River District Design Commission

MARCH 14, 2019
4:00 P.M.
FOURTH FLOOR CONFERENCE ROOM

MEETING OF MARCH 14, 2019

DANVILLE PARKS & RECREATION
COMMUNITY MARKET DECK - ROOF STRUCTURE
629 CRAGHEAD STREET, DANVILLE, VA 24541
PRELIMINARY DESIGN

EXISTING NORTHWEST AND PARTIAL SOUTHWEST FACADE

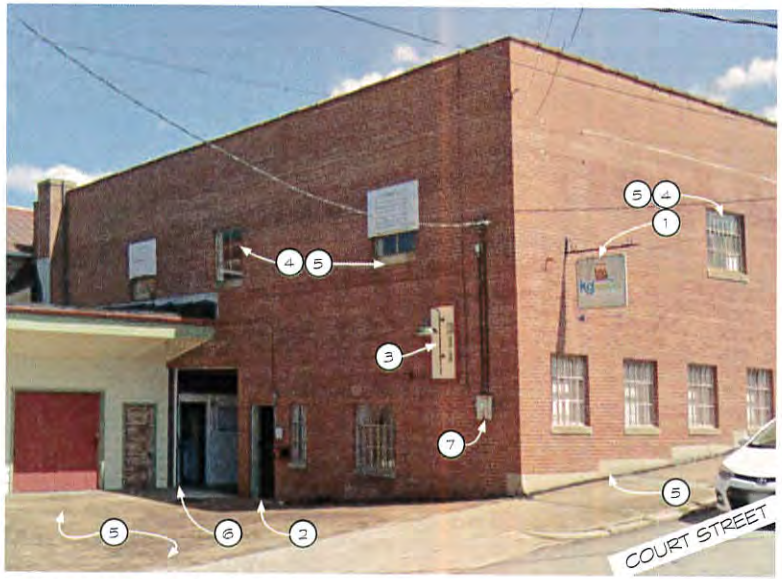
Item A (install bronze-top awning) requests to add two (2) new features using appropriate design and material for a historic industrial building. Staff recommends the Commission issue a Certificate of Appropriateness at 311 Court St. to install two (2) new bronze-top metal awnings, one (1) above entryway and one (1) to right of entryway above window

Item B (remove or paint frame panel) presents two (2) options regarding an existing frame panel associated with an exterior light. Removal of historical features (first option) is not generally recommended, but painting (second option) may be permitted when appropriate for the character of the building. Therefore, staff recommends the Commission issue a Certificate of Appropriateness at 311 Court St. to paint, but not remove, the existing frame panel (fiery brown).

Item C (replace door) requests to replace an existing door with a new door to match both the façade changes and respect the historical character of the storefront. Staff recommends the Commission issue a Certificate of Appropriateness at 311 Court St. to replace wood door with a wood door including smaller glass six (6) pane windows, and new paint color (fiery brown).
